## MC33989 Silicon Mask Errata

This errata applies to the MC33989 device. It describes the specific conditions and events necessary for the occurrence of an unexpected reset. Work around solutions to avoid the reset are also described.

- MC33989DWB/R2
- MCZ33989EG/R2 (Pb-Free)

Figure 1.  $\overline{\text{CS}}$  low for a single SPI command

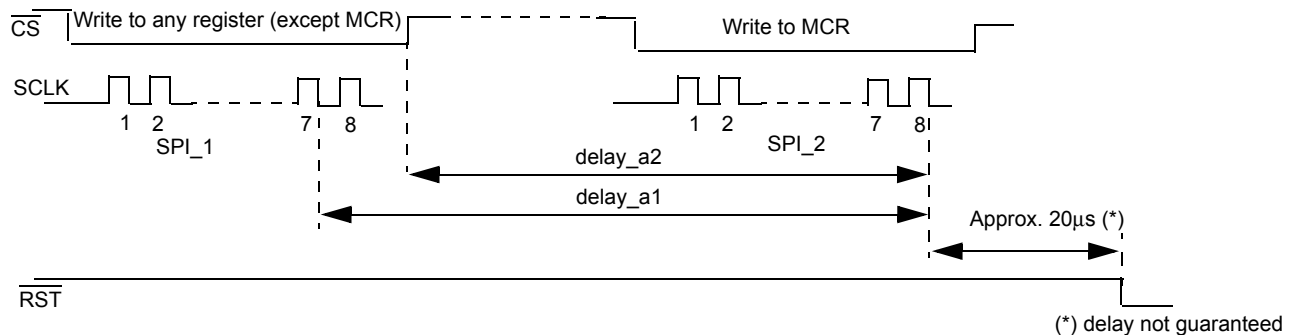
A reset may occur if the "delay\_a1" or "delay\_a2" is between 17.6 $\mu$ s and 22.4 $\mu$ s.

Definition of "delay\_a1": this is the delay between the falling edge of 7th clock of the SPI\_1 and the falling edge of the 8th clock of SPI\_2.

Definition of "delay\_a2": this is the delay between the rising edge  $\overline{\text{CS}}$  of the SPI\_1 and the falling edge of the 8th clock of SPI\_2.

Note: the 17.6 $\mu$ s and 22.4 $\mu$ s values are derived from the tolerance of the period of the internal clock signal. As stated above, a reset will occur if "delay\_a" is within the above window AND if the phase condition are matched. Both conditions are necessary, and this mean that reset will not occur every time "delay\_a" is within the 17.6 to 22.4 $\mu$ s window.

The work around is to ensure that the "delay\_a1" AND "delay\_a2" are shorter than 17.6 $\mu$ s or longer than 22.4 $\mu$ s. This will prevent the phase conditions between internal clock signal and SPI signals to be matched.

*In order to be safe, the recommendation is to use "delay\_a1" longer than 25 $\mu$ s.*

**Figure 2.  $\overline{CS}$  low for more than one SPI command**

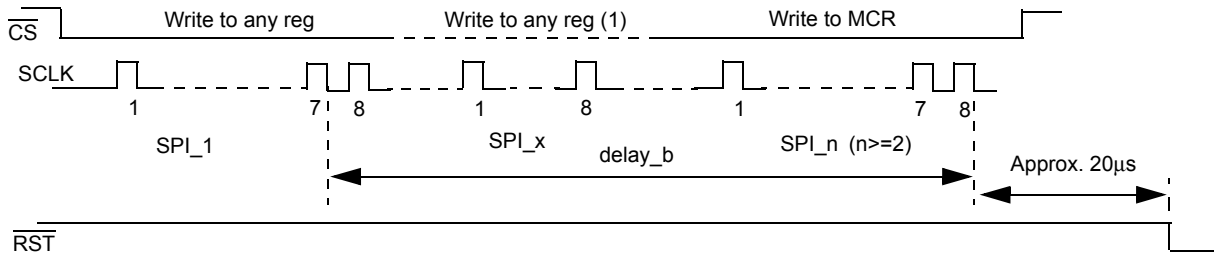
A reset may occur if the "delay\_b" between the falling edge of the 7th clock pulse of "SPI\_1" and the falling edge of the 8th clock pulse of "SPI\_n" is longer than 8.8 $\mu$ s. SPI\_n is the last SPI command occurring while  $\overline{\text{CS}}$  is held low.

Definition of "delay\_b": this is the delay between the falling edge of 7th clock of the SPI\_1 and the falling edge of the 8th clock of SPI\_n.

Note: the 8.8 $\mu$ s value is derived from the tolerance of the period of the internal clock signal. As stated above, a reset will occur if "delay\_b" is greater than 8.8 $\mu$ s AND if the phase conditions are matched. This mean that reset will not occur every time "delay\_b" is > 8.8 $\mu$ s.

Figure 2 below is the illustration for case 2, when both conditions for “delay\_b” and “phase” are met.

(1): Not same register as previous SPI command, other wise respect “T2spi” delay described in device data sheet

If the  $\overline{CS}$  has to be maintained low for the series of SPI write commands (which includes the MCR write), “delay\_b” must be shorter than  $8.8\mu s$ . The “delay\_b” is considered from the first SPI command occurring after a  $\overline{CS}$  low transition to the MCR write command (ref to fig 2), so in the case of many SPI commands (i.e 3 or more) such delay will likely not be met, due to SPI frequency limitation.

**Figure 3. work around when  $\overline{CS}$  is maintained low for several SPI commands**

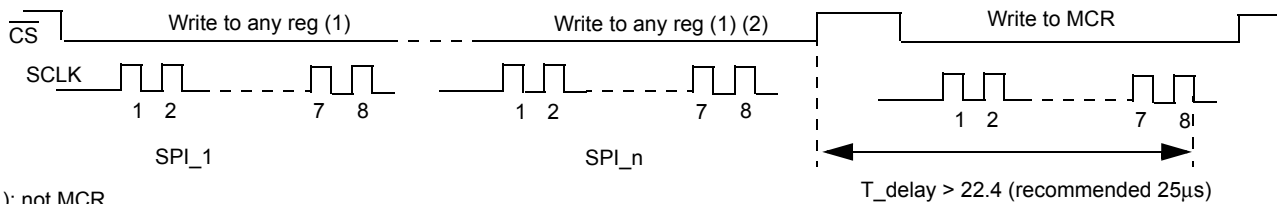
(1): not MCR

(2): not same register as previous SPI command, other wise respect “T2spi” delay described in device data sheet

A more practical solution is to ensure that the MCR write command occurs with a dedicated high to low transition on  $\overline{CS}$ , AND to ensure that the delay between the  $\overline{CS}$  rising edge of the previous SPI commands and the 8th clock pulse of the MCR write command is greater than  $22.4\mu s$ .

**In order to be safe, the recommendation is to use “T\_delay” longer than  $25\mu s$ .**

The work around is illustrated in the figure below:
